**OceanView at Cumberland, Tuttle Road, Cumberland
Revised Preliminary Subdivision Plan Submittal –*ADDENDA-1A*
(Map R04 Parcels 4B, 4D, 4E and 5)**

Subject: Peer Review of OceanView At Cumberland
Major Subdivision and Site Plan Application – Preliminary Review
Tuttle Road, Cumberland, Maine

Subject: Peer Review of OceanView At Cumberland
Preliminary Stormwater Review for Major Subdivision and Site Plan Application
Tuttle Road, Cumberland, Maine

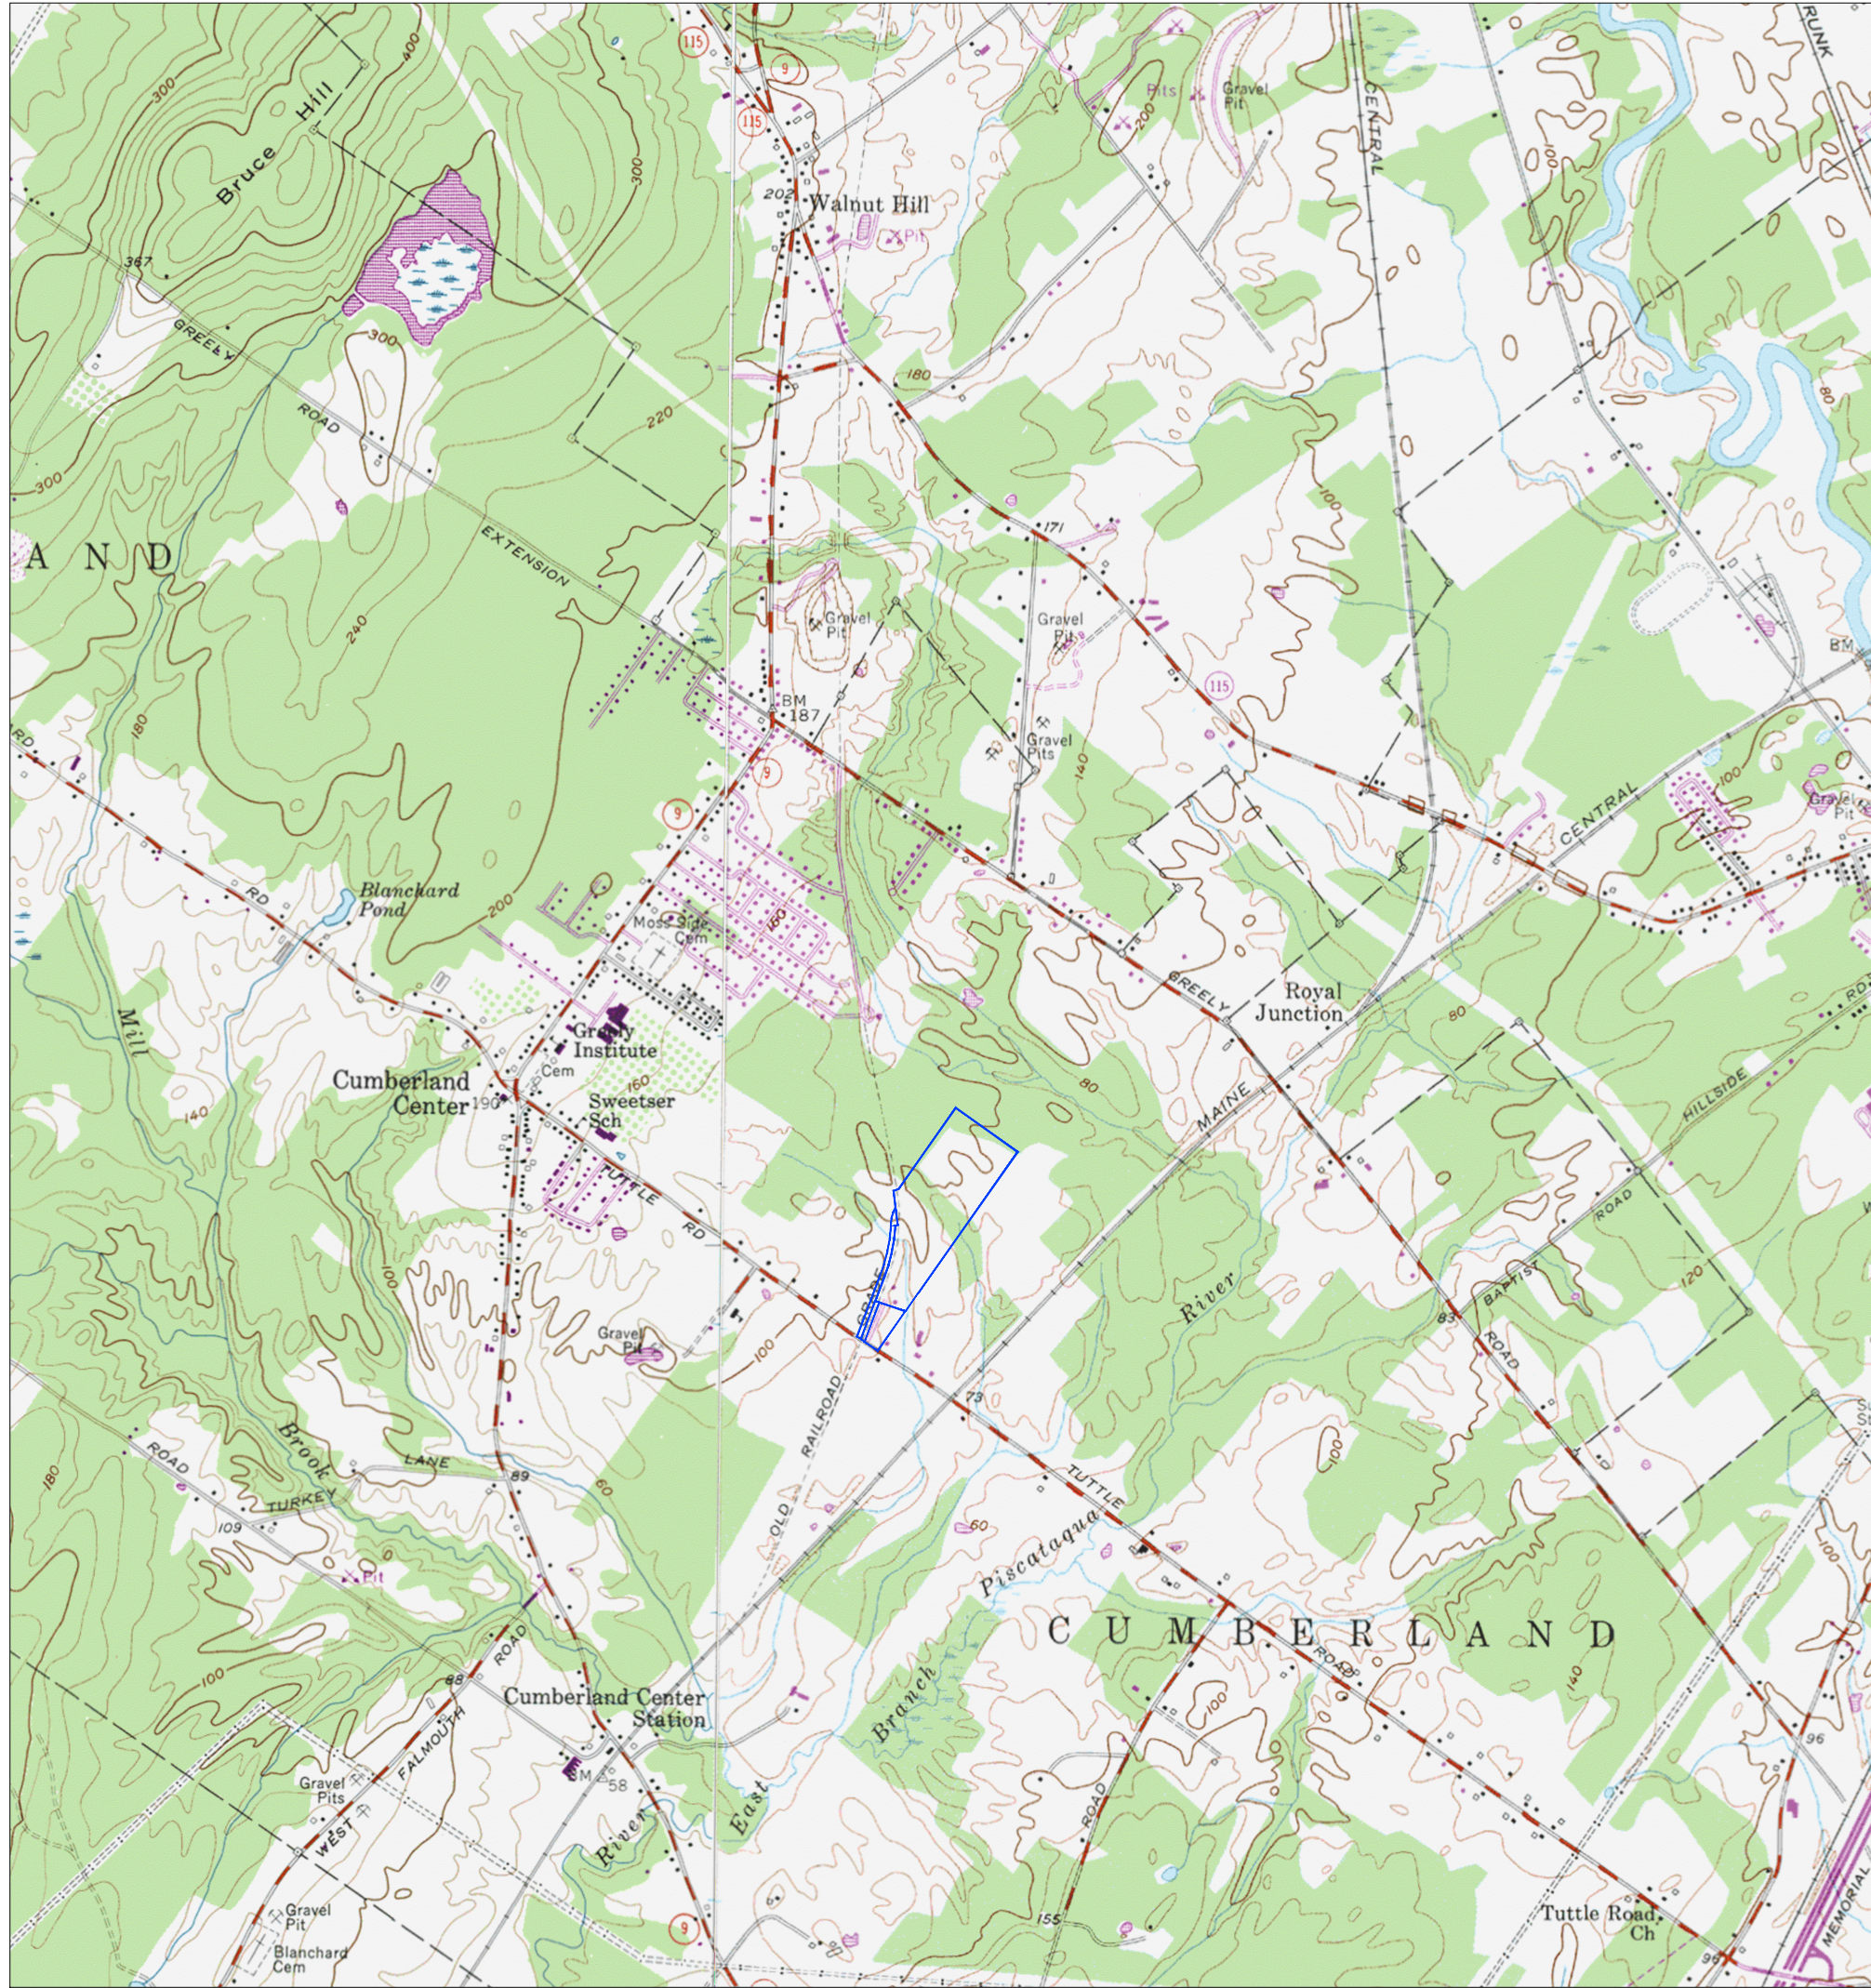
24. Plan Sheet C0 – Approvals Required Note 2 references a MEDEP SLODA permit *amendment*. Please update the plan to clarify the current project permitting status. *Cover sheet has been updated and NRPA and MDOT permits added.*

S-1 Sheet 1 of 4

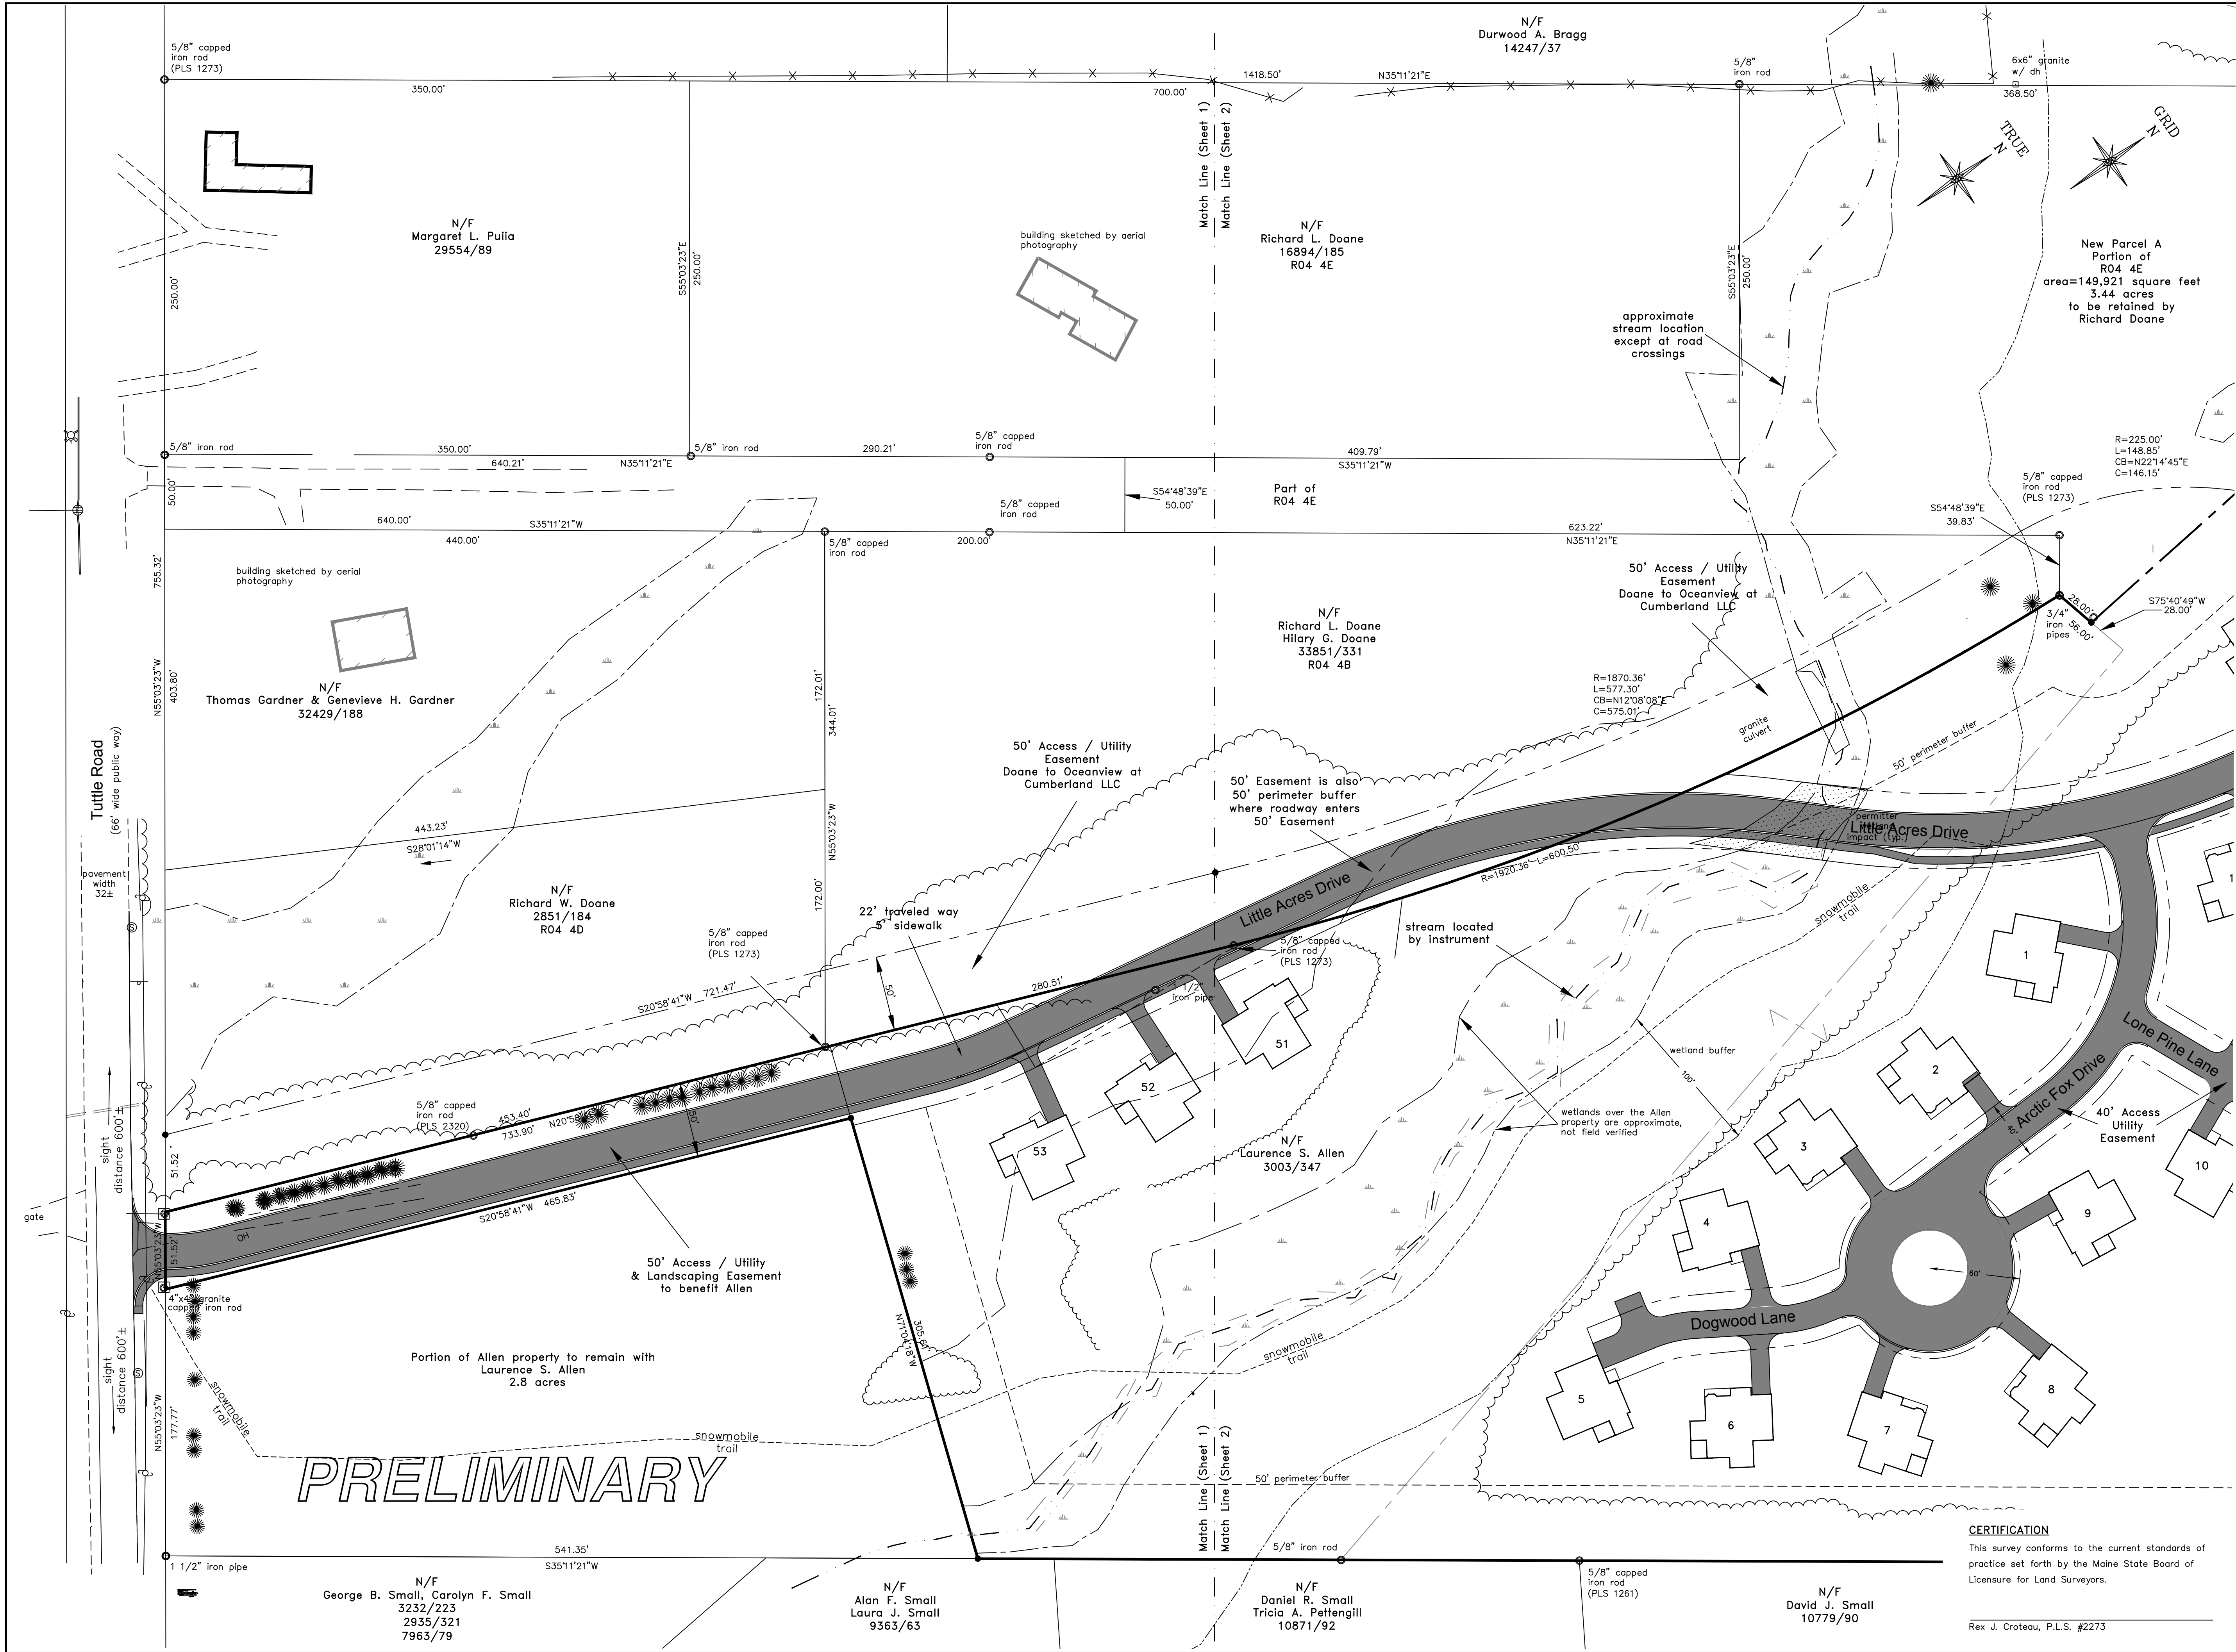
25. Subdivision Plat S1 – The plan outlines overhead electric service from Tuttle Road to Units 51, 52 and 53. The application outlines underground utilities. Please clarify. *The overhead line are existing (to the Allen Residence) and have been removed from the subdivision plat.*

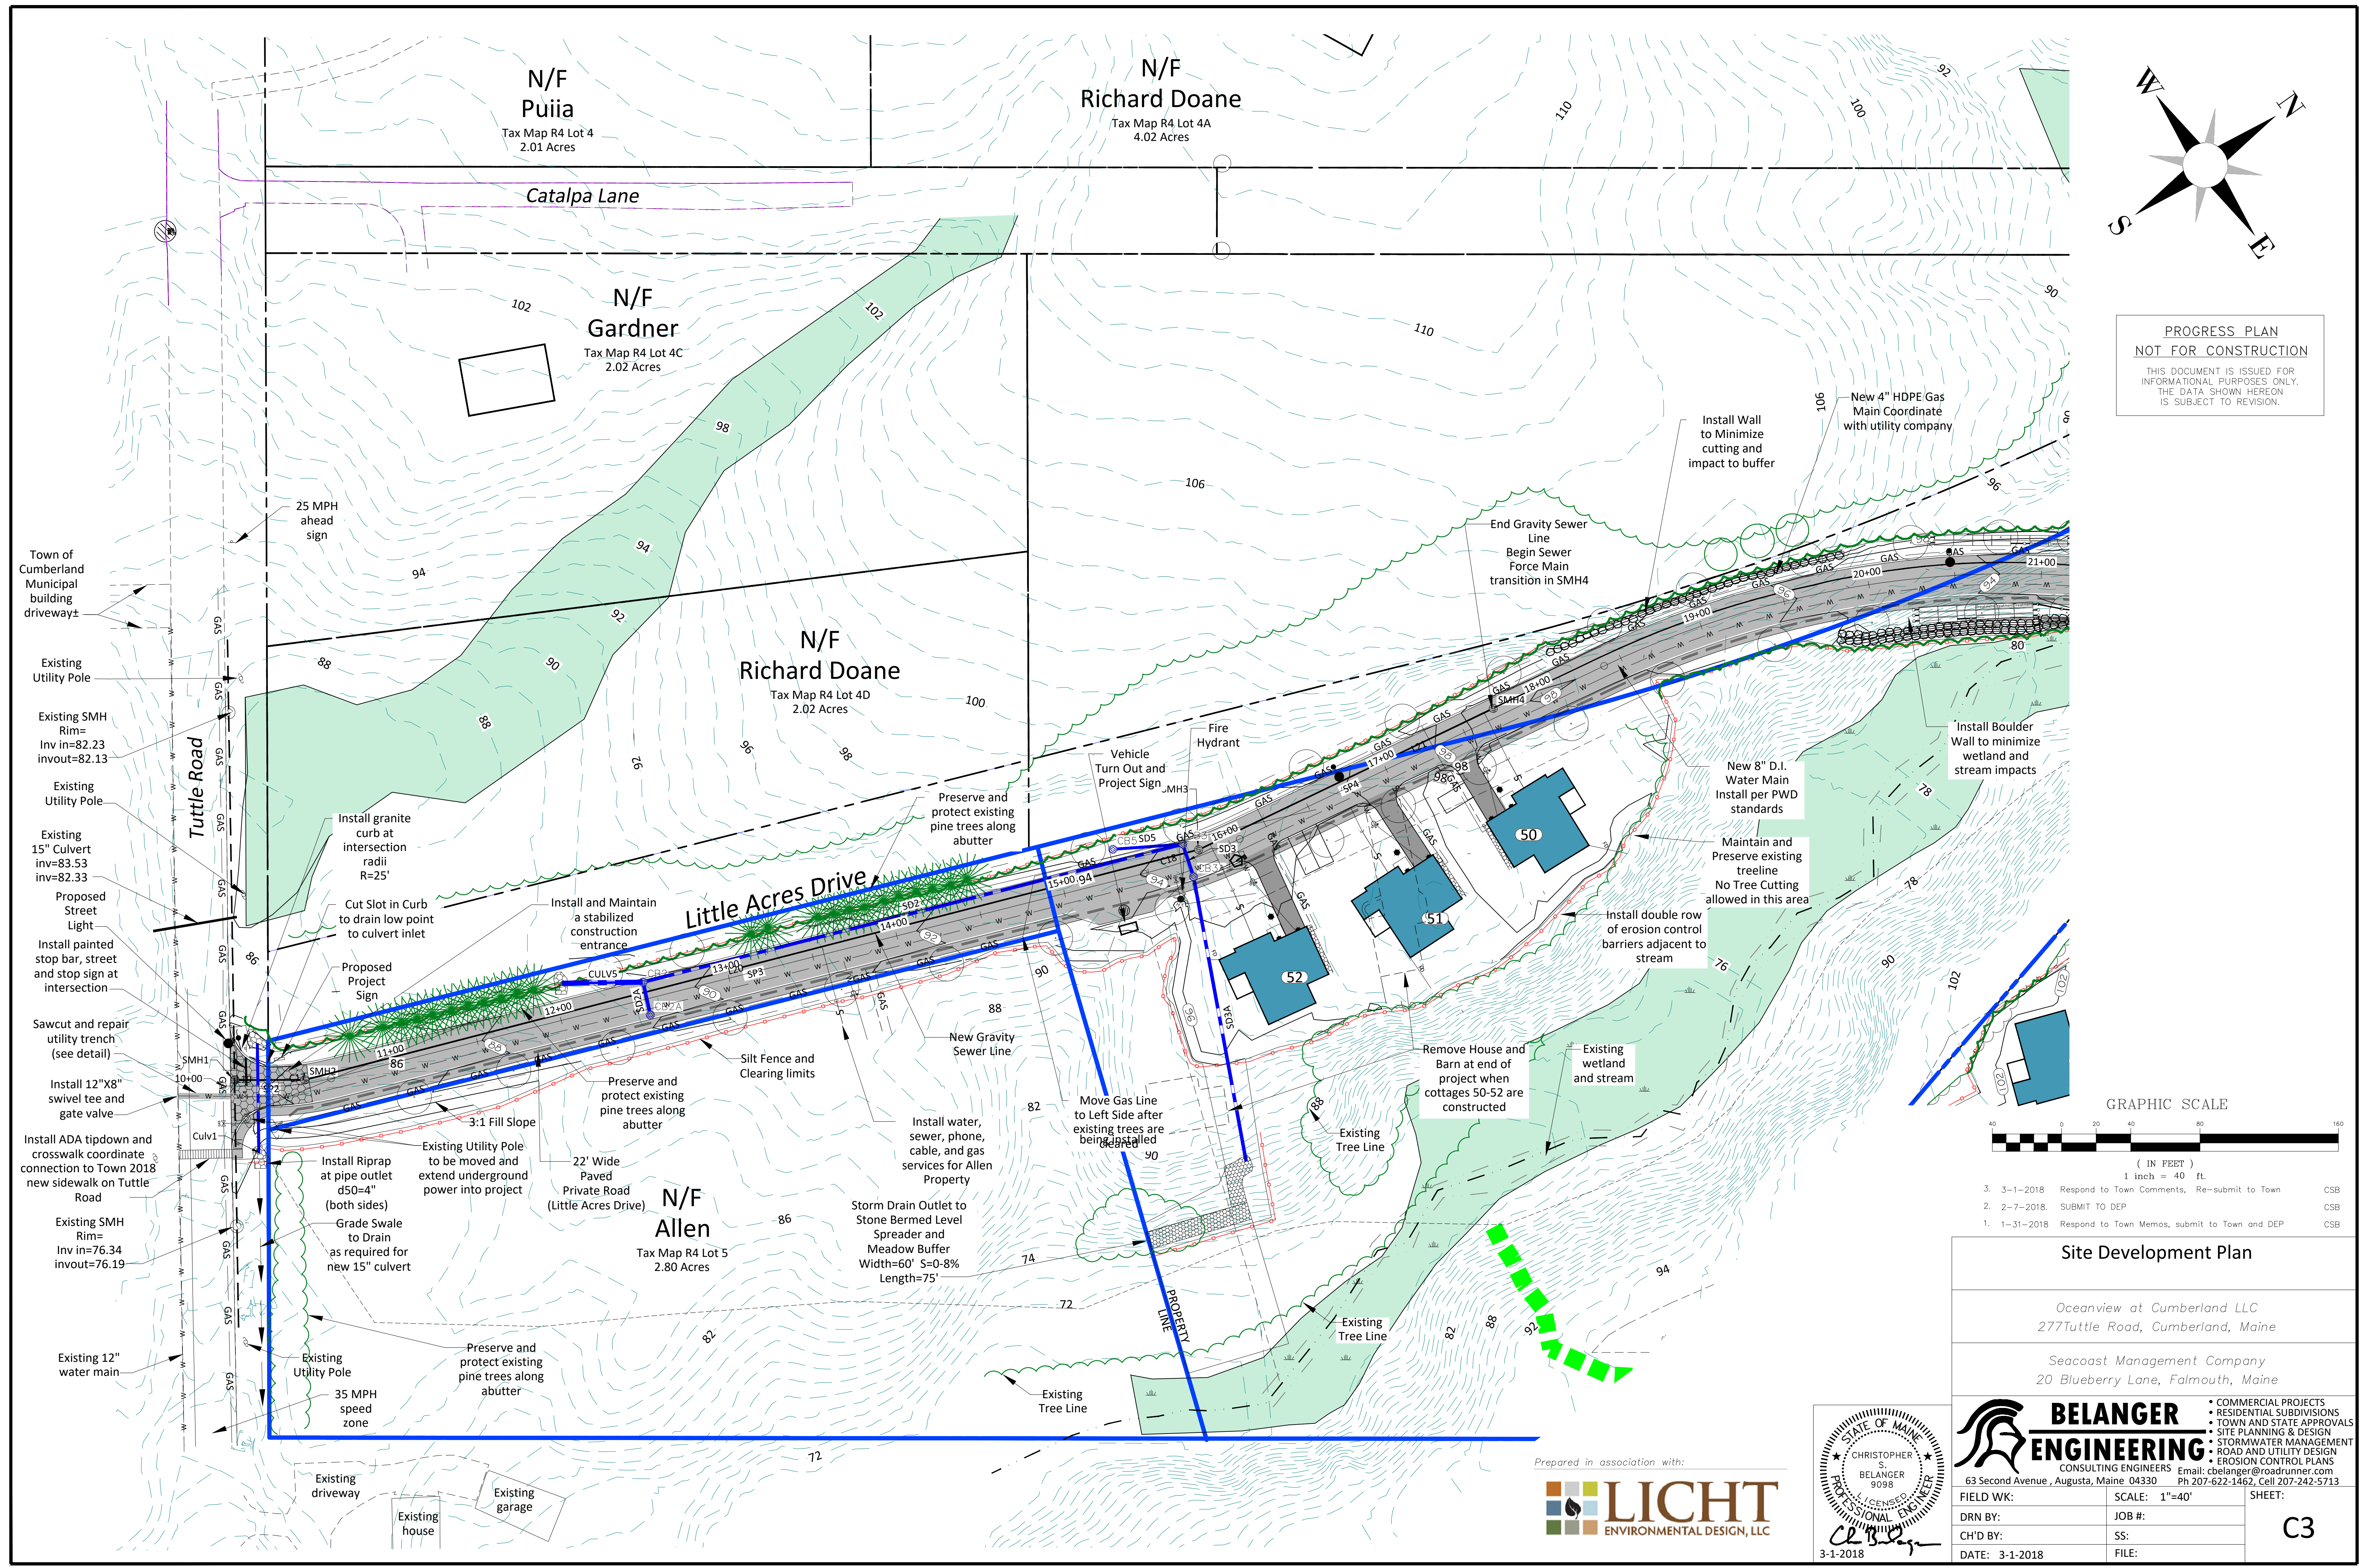
4. The cover letter outlines 11,200 sf +/- of proposed wetland impacts. Plan sheet C2 outlined 12,700 sf of proposed wetland impacts. Please clarify. *The revised submission has been updated to reflect 12,700 sf of wetland impacts, consistent with the DEP-NRPA Tier-1 application.*
